**RESPONSES OF WINDHAM SOLAR, LLC
TO
CONNECTICUT SITING COUNCIL INTERROGATORIES - SET ONE**

On August 10th, 2020, the Connecticut Siting Council (“Council”) issued Interrogatories, Set One to Windham Solar, (“Petitioner”), relating to Petition No. 1359A. The Petitioner offers the following responses.

| | PROJECT CROSS SECTION | Date: 2/11/2020 Sheet No. 9 |

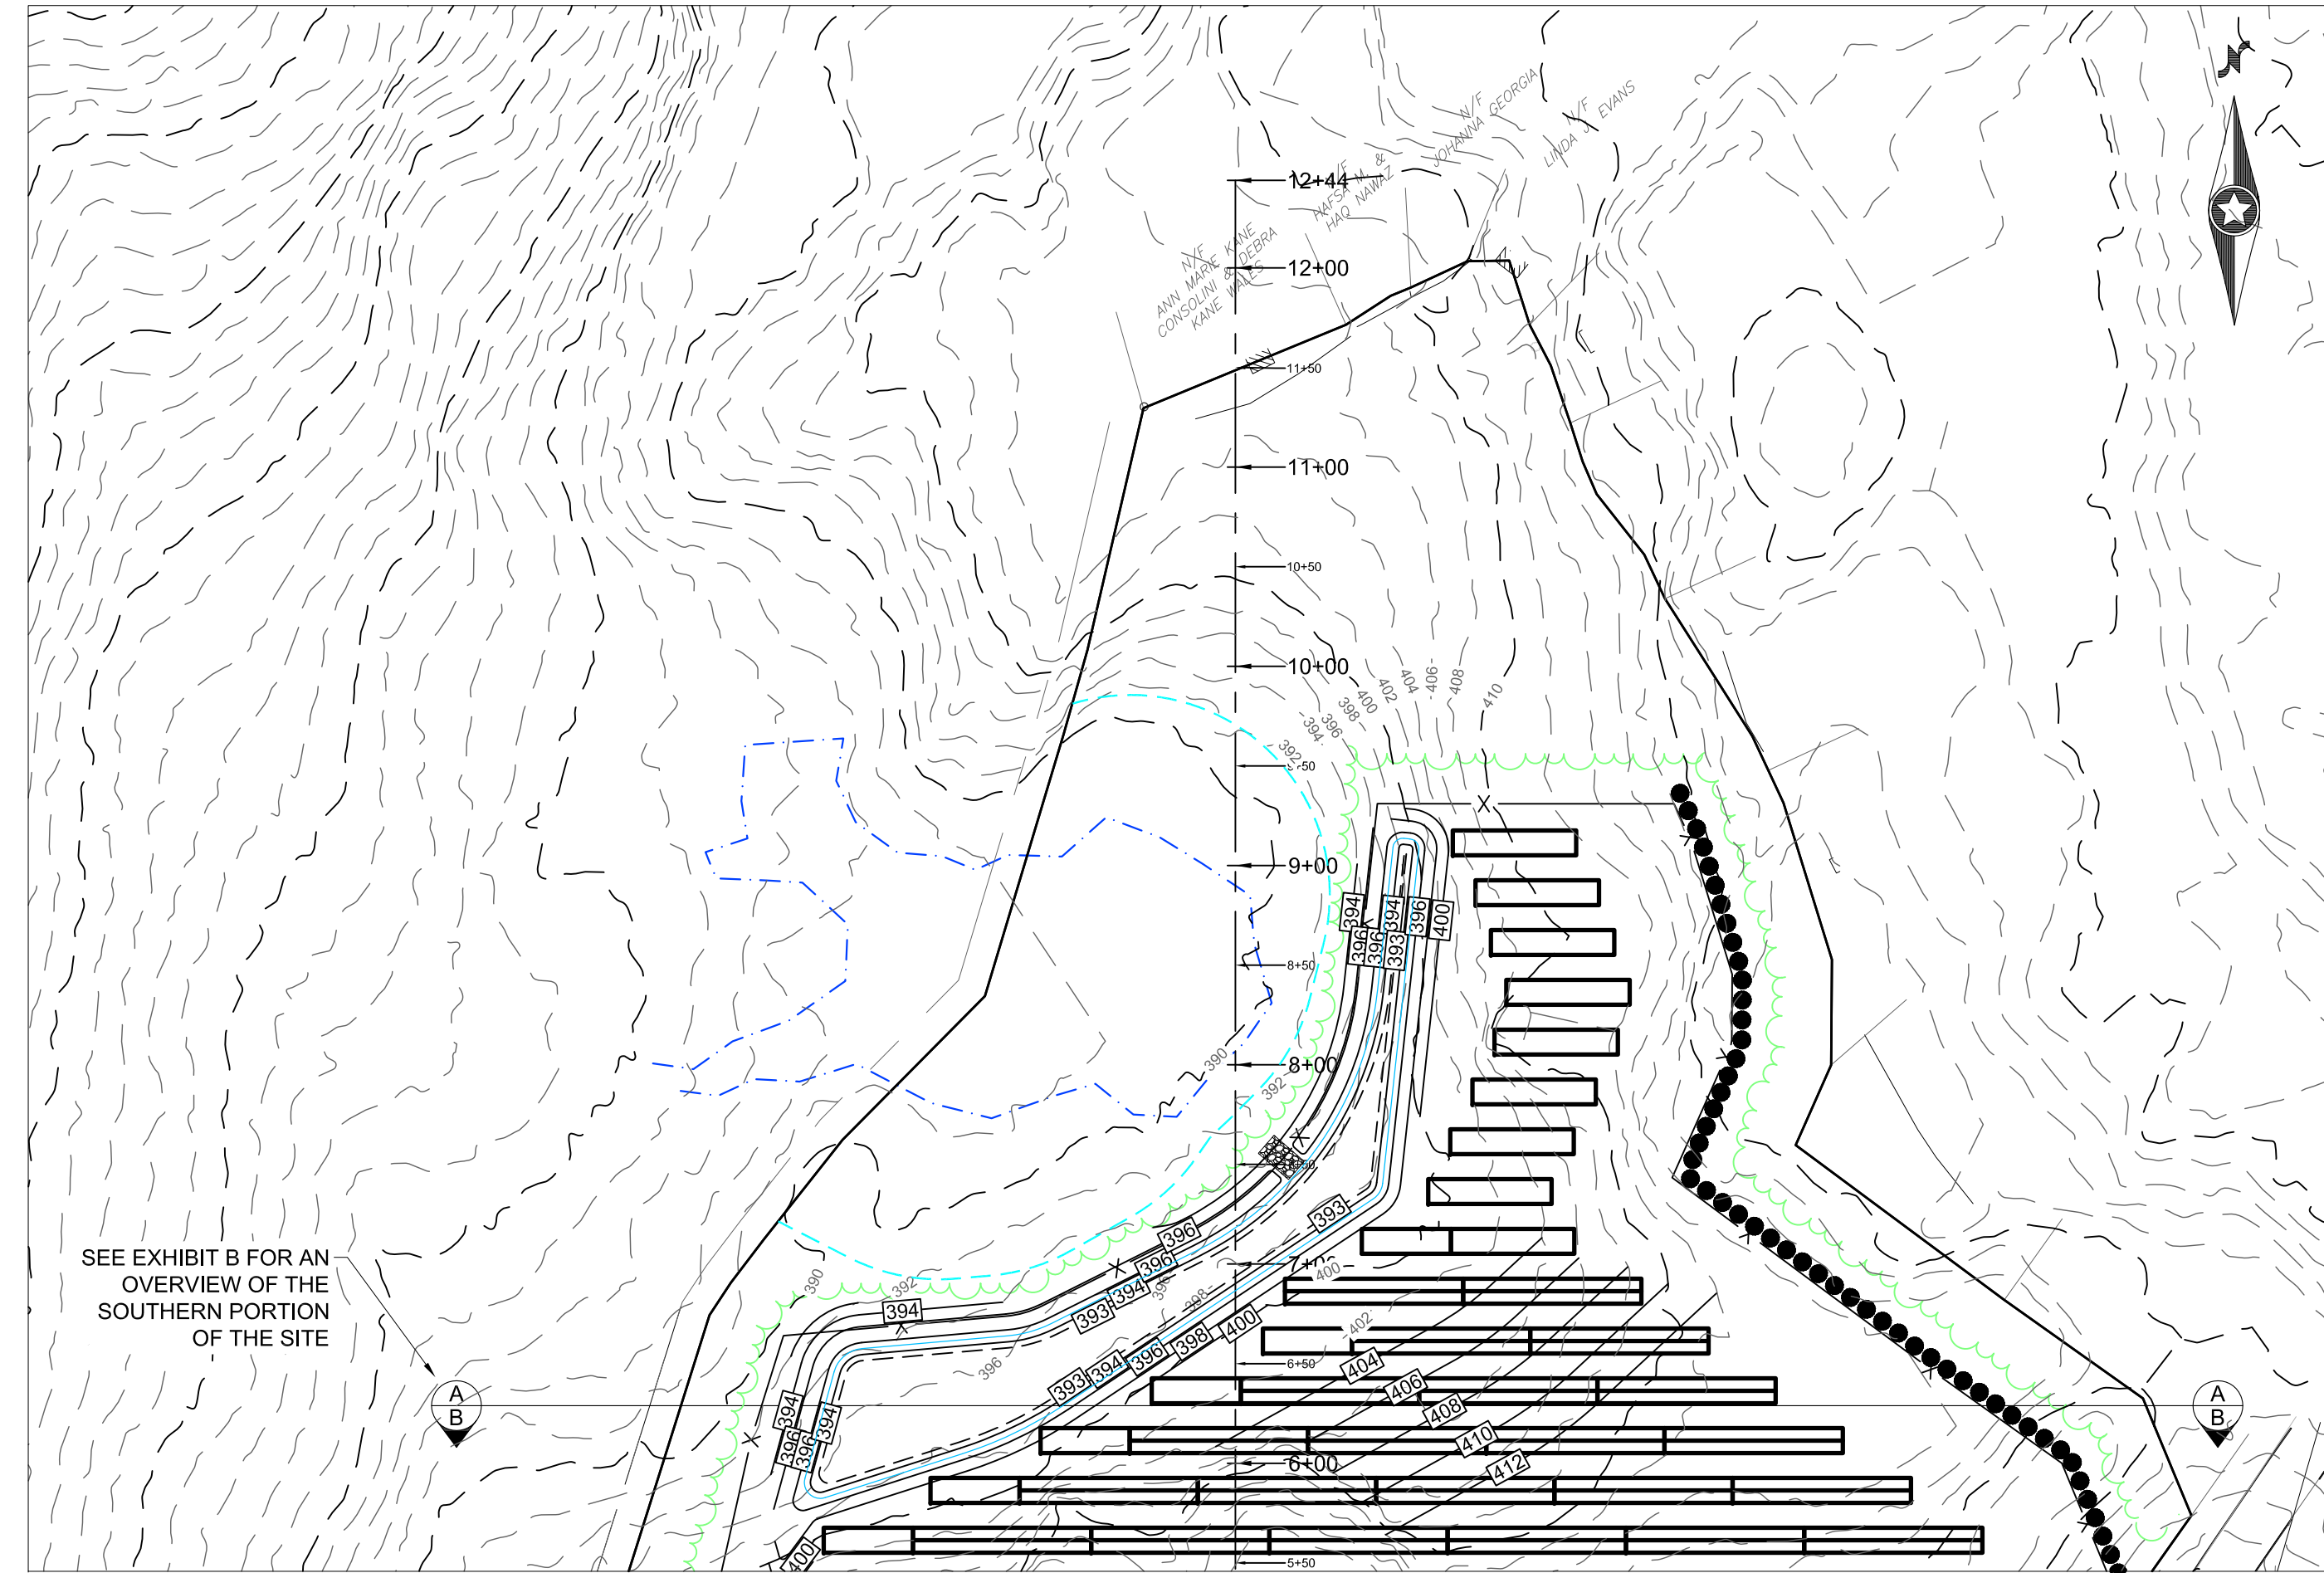
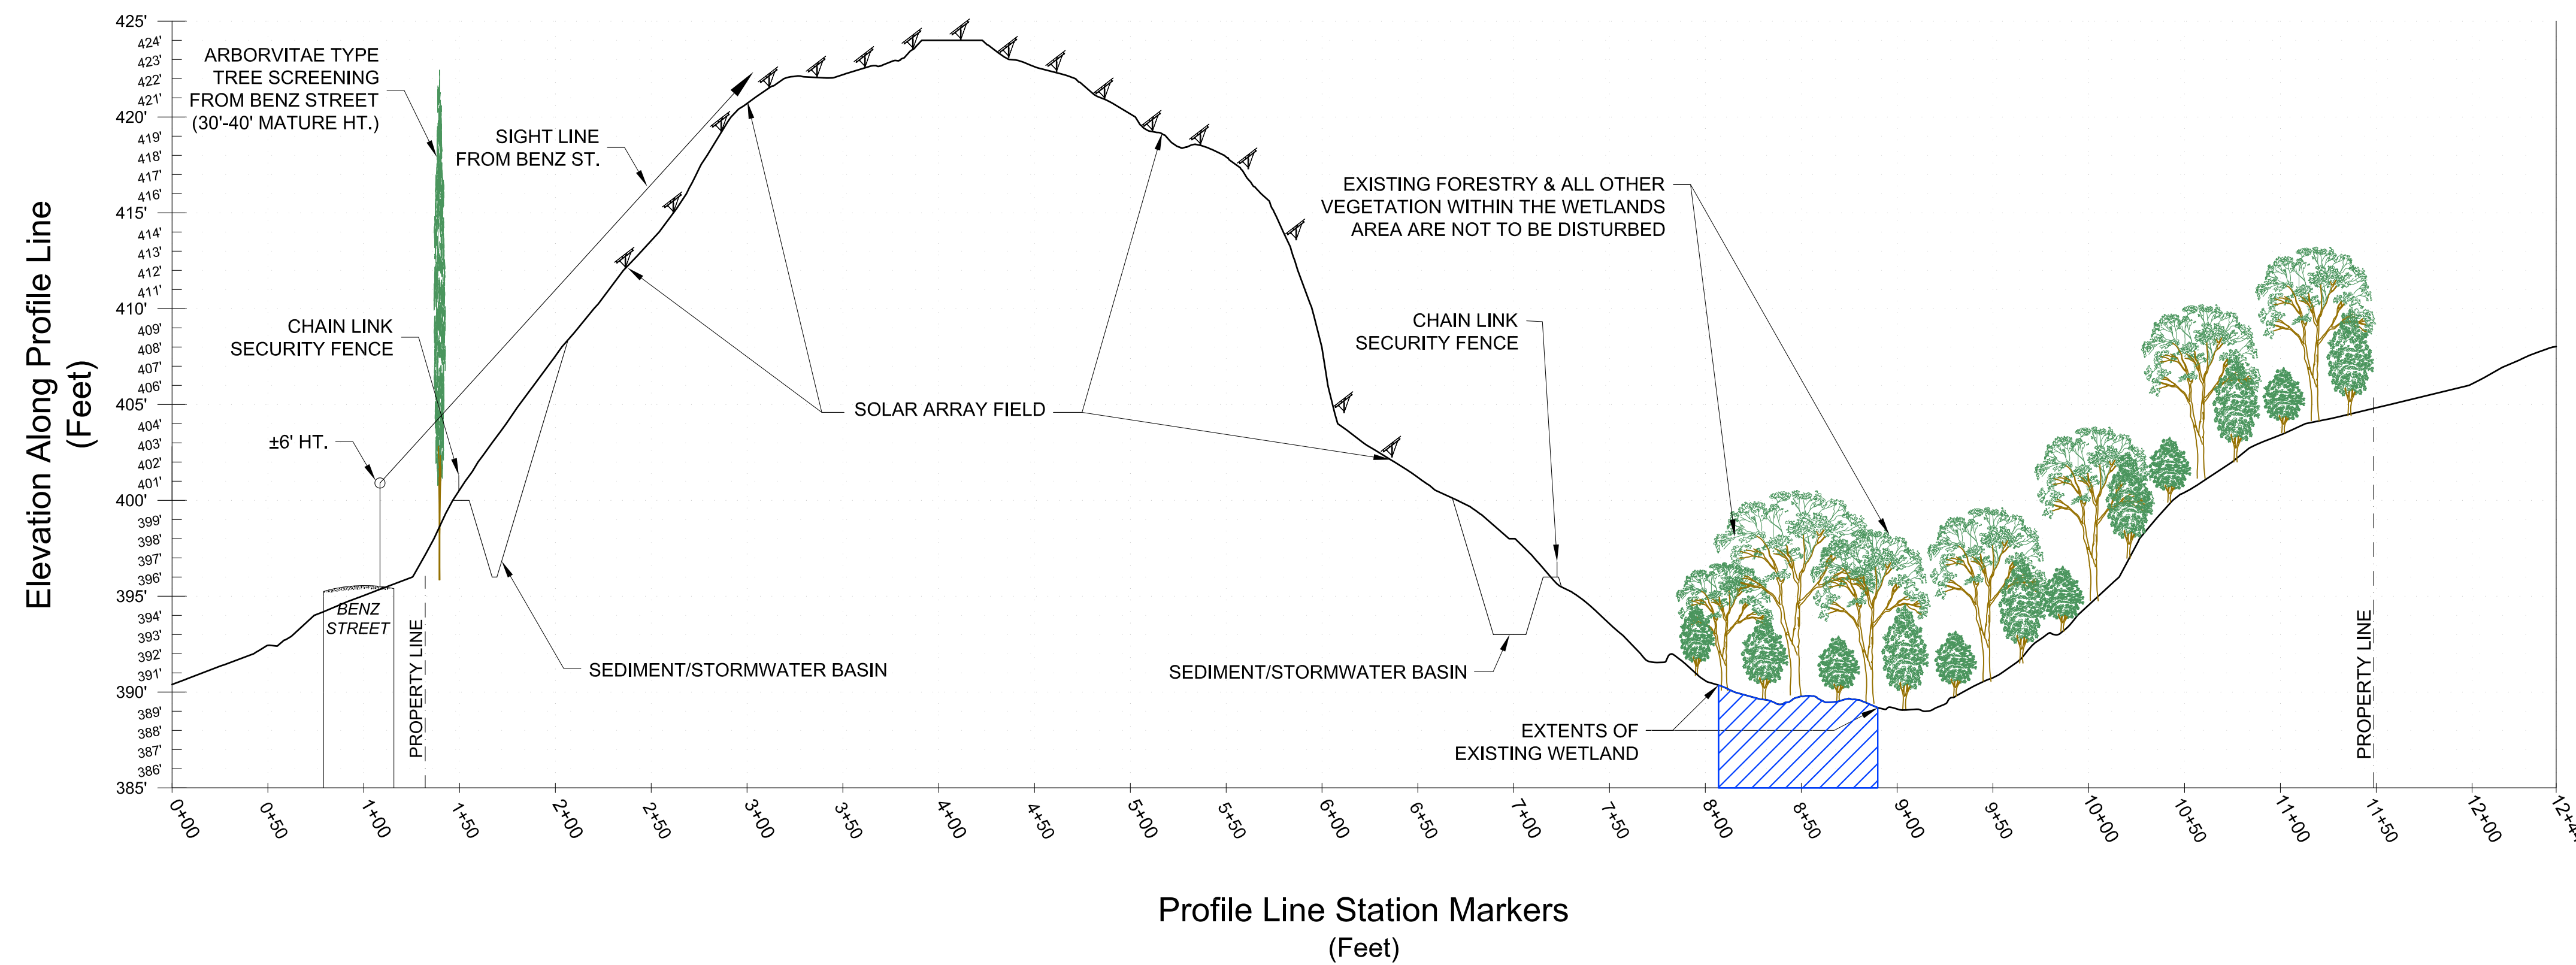
9. Referring to Site Plan Sheet 9 (Project Profile), how will the arborvitae along Benz Street be able to screen the solar arrays from the road if they are at a higher elevation?

The screen hedge interrupts the sight line up the hill, thus screening the modules. An appropriate tree profile of the mature height trees has been inserted into the cross section and a site line from Benz Street has been added to the cross section to represent the screening of the facility from the roadway. *Exhibit A – Sheet 9*.
